2022-2024
State of New Mexico
Clean Water Act
§303(d)/§305(b)
Integrated Report

Appendix C
Response to Comments

RESPONSE TO COMMENTS
ON THE
2022-2024 STATE OF NEW MEXICO
CLEAN WATER ACT
§303(d)/§305(b)
INTEGRATED LIST OF ASSESSED SURFACE WATERS

February 4, 2022

7. S-Site Canyon (Water Canyon to headwaters)

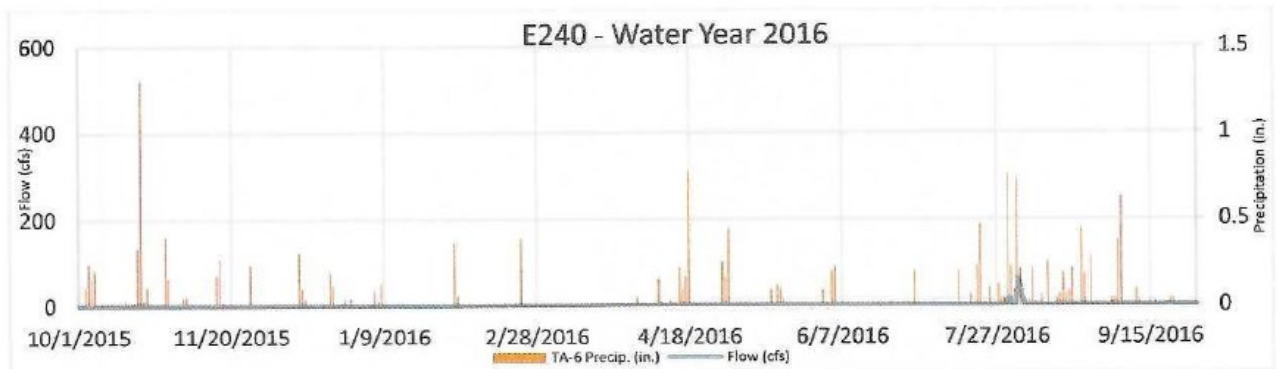
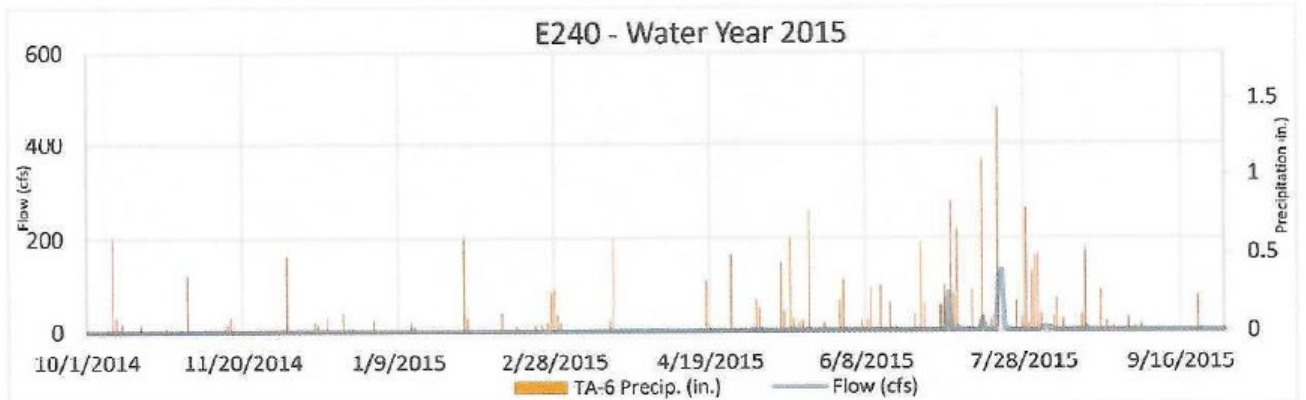
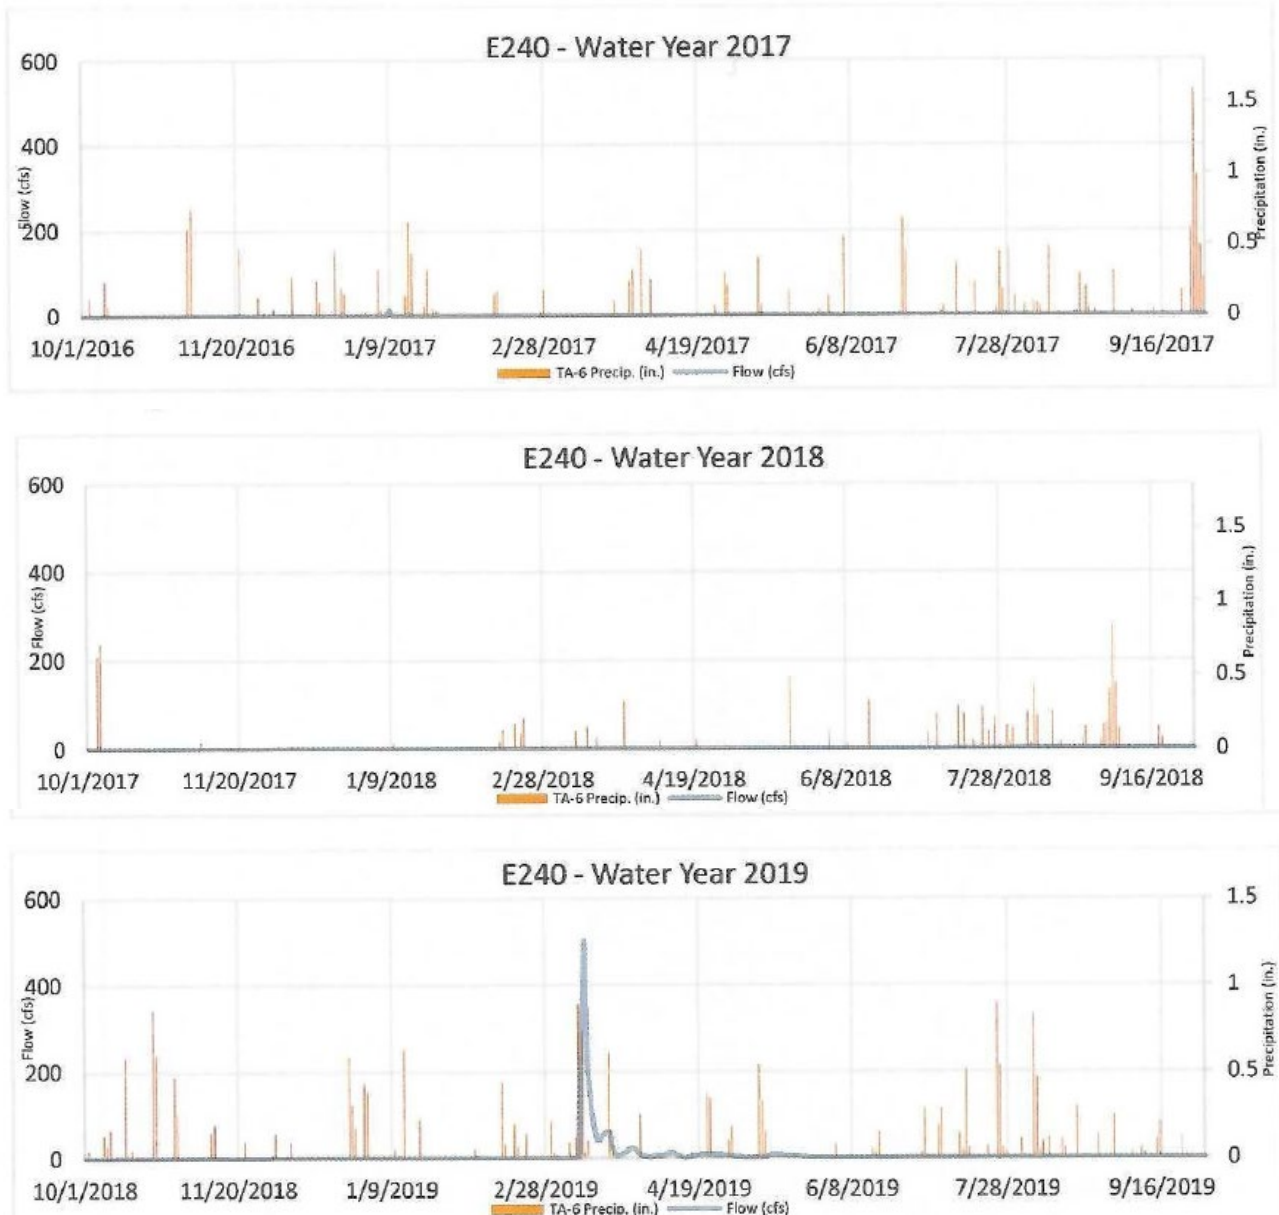
NMED should amend the draft Integrated List to reflect recent HP data for S-Site Canyon (Water Canyon to headwaters). The draft Integrated List currently identifies the "Water Type" as intermittent for S-Site Canyon (Water Canyon to headwaters). However, S-Site Canyon was subject to Joint Level 1 HP evaluations conducted by NMED and LANL, as well as Level 2 HP evaluations conducted by LANL. Those evaluations demonstrate that S-Site Canyon has ephemeral flow characteristics from its confluence with Water Canyon to alluvial well MSC16-06293. The HP scores for this reach are 8 and 9. The HP evaluations then demonstrate that S-Site Canyon has intermittent flow characteristics from alluvial well MSC16-06293 upstream to Martin Spring, with an HP score of 16. Therefore, LANL recommends that NMED split the current AU for S-Site Canyon (Water Canyon to headwaters) into two separate AUs: (1) S-Site Canyon from its confluence with Water Canyon to alluvial well MSC16-06293, with a "Water Type" identified as ephemeral; and (2) S-Site Canyon from alluvial well MSC16-06293 upstream to Martin Spring, with a "Water Type" identified as intermittent.

This is a matter pending before the Water Quality Control Commission, docketed as WQCC 20-51 (R). NMED will split the AU appropriately depending on the final Commission decision and subsequent EPA approval.

8. Pajarito Canyon (Above Homestead Spring to LANL boundary)

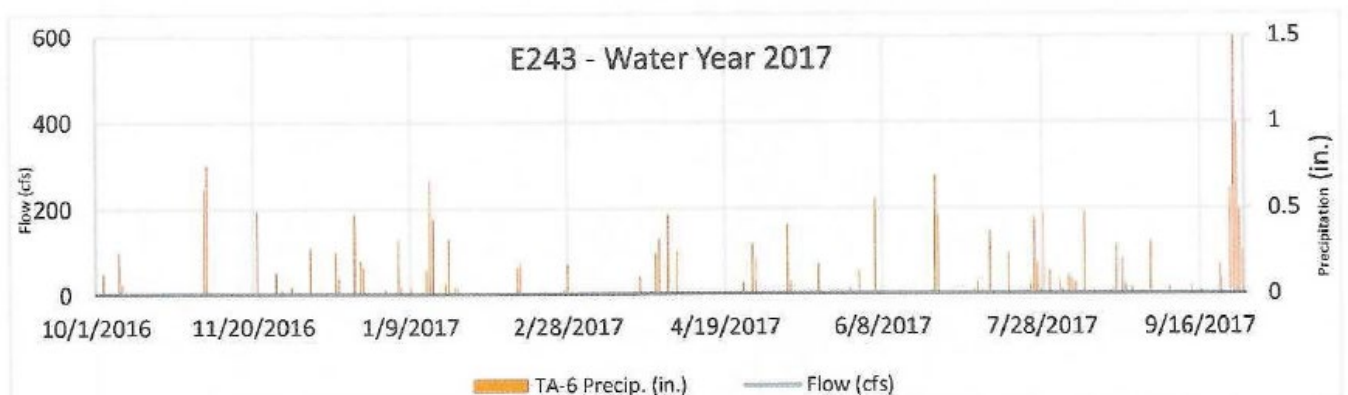
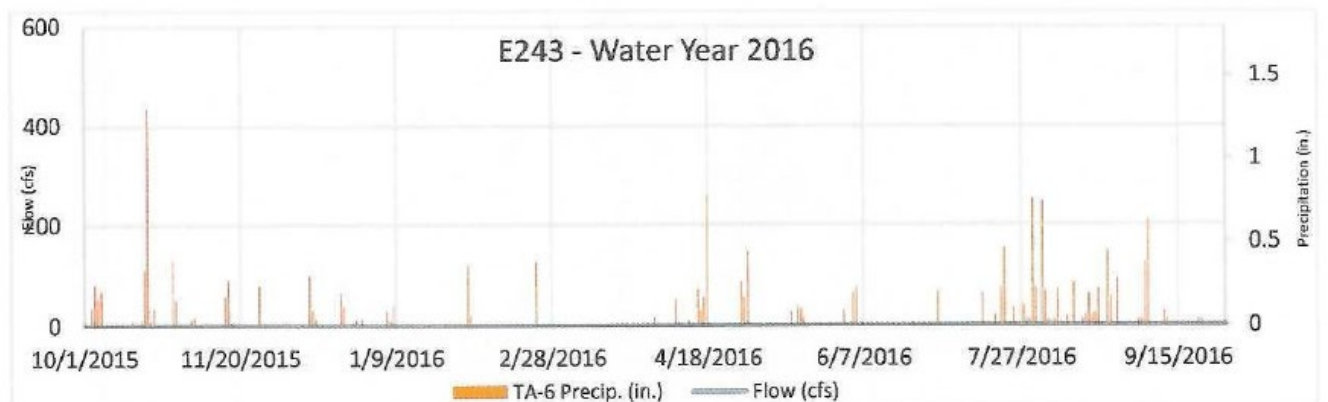
NMED should also amend the draft Integrated List to reflect recent HP data for Pajarito Canyon (Above Homestead Spring to LANL boundary). The draft Integrated List currently identifies the "Water Type" as intermittent for Pajarito Canyon (Above Homestead Spring to LANL boundary). Pajarito Canyon was subject to Joint Level 1 HP evaluations conducted by NMED and LANL, as well as Level 2 HP evaluations conducted by LANL. The HP score for this reach is 14, and the Level 2 HP evaluation found no evidence of intermittent conditions within this reach. In fact, flows from stream gage E240, located 0.8 miles above HP site between 2007 and 2019, indicate less than 8 percent days/year with flow. Based on these data, LANL recommends that NMED revise the Integrated List to identify the "Water Type" as ephemeral for Pajarito Canyon (Above Homestead Spring to LANL boundary).

The hydrographs below from stream gage E240 indicate that flows are predominantly the direct result of precipitation, further supporting the conclusion that NMED should identify Pajarito Canyon (Above Homestead Spring to LANL boundary) as ephemeral in the Integrated List.

Agreed. Pajarito Canyon (Above Homestead Spring to LANL boundary) is classified under 20.6.4.128 NMAC, which specifies “ephemeral and intermittent portions of watercourses...” within LANL. Therefore, NMED has amended the “Water Type” in the Draft 2022-2024 Integrated List from “STREAM, INTERMITTENT” to “STREAM, EPHEMERAL” based on hydrograph data and HP work that indicate this waterbody has ephemeral flow characteristics.

9. Pajarito Canyon (Twomile Cyn to 500m ds of A. de La Delfe)

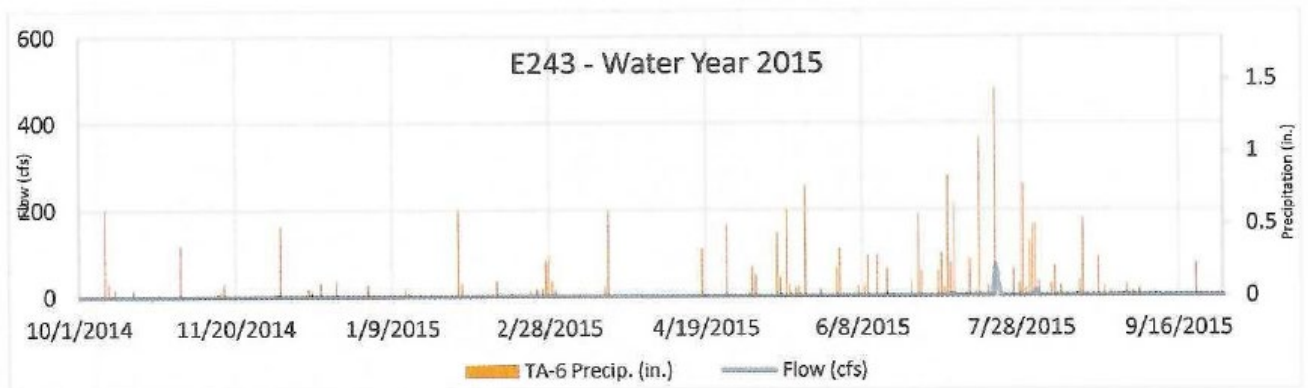
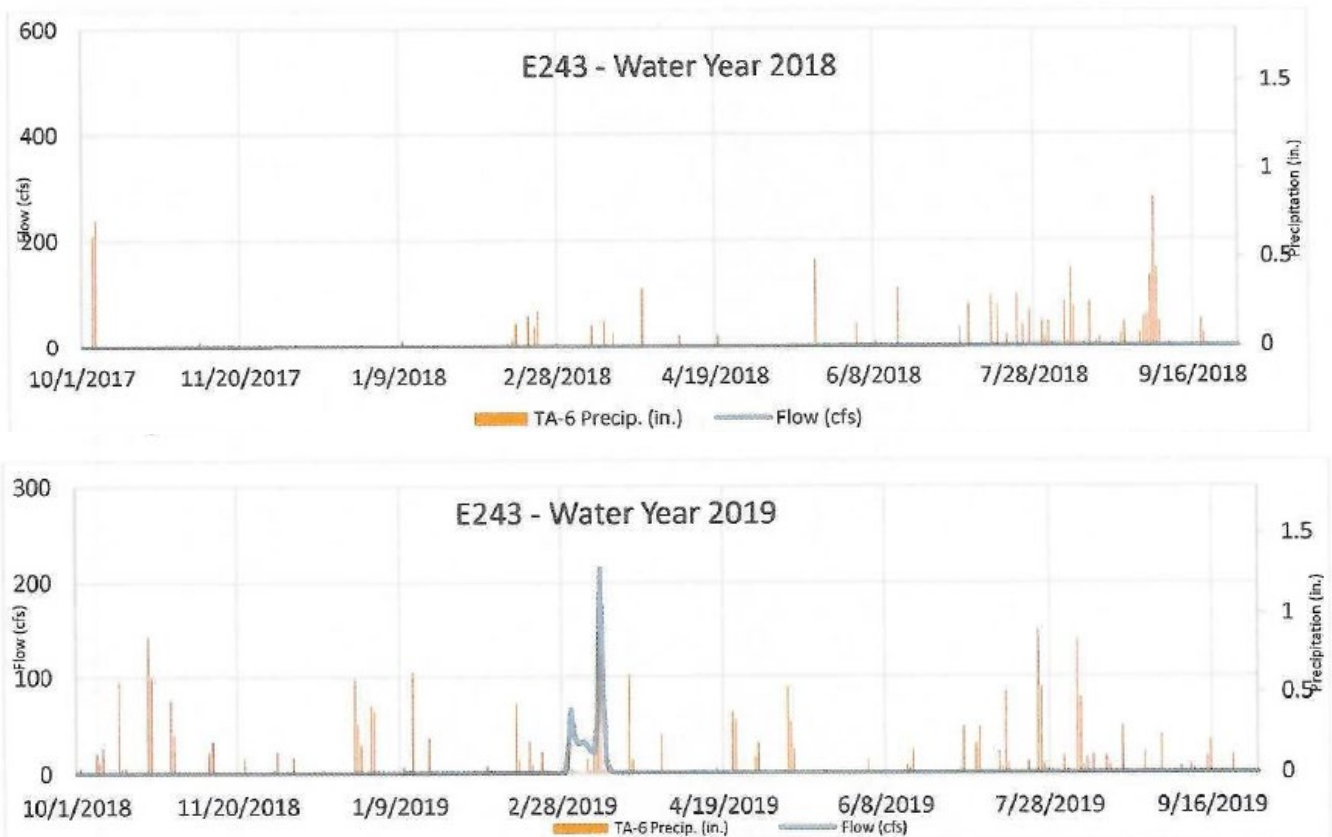
NMED should also amend the draft Integrated List to reflect recent HP data for Pajarito Canyon (Twomile Cyn to 500m ds of A. de La Delfe). The draft Integrated List currently identifies the "Water Type" as intermittent for this reach. Pajarito Canyon was subject to Joint Level 1 HP evaluations conducted by NMED and LANL, as well as Level 2

HP evaluations conducted by LANL. The HP score for this reach is 8. Furthermore, the hydrographs below from stream gage E243, which is located 0.2 miles above the confluence with Twomile Canyon, demonstrate that this reach has ephemeral flow conditions. Accordingly, LANL recommends that NMED revise the Integrated List to identify the "Water Type" as ephemeral for Pajarito Canyon (Twomile Cyn to 500m ds of A. de La Delfe).

Agreed. Pajarito Canyon (Twomile Cyn to 500m ds of A. de La Delfe) is classified under 20.6.4.128 NMAC, which specifies “ephemeral and intermittent portions of watercourses...” within LANL. Therefore, NMED has amended the “Water Type” in the Draft 2022-2024 Integrated List from “STREAM, INTERMITTENT” to “STREAM, EPHEMERAL” based on hydrograph data and HP work that indicates this waterbody has ephemeral flow characteristics.
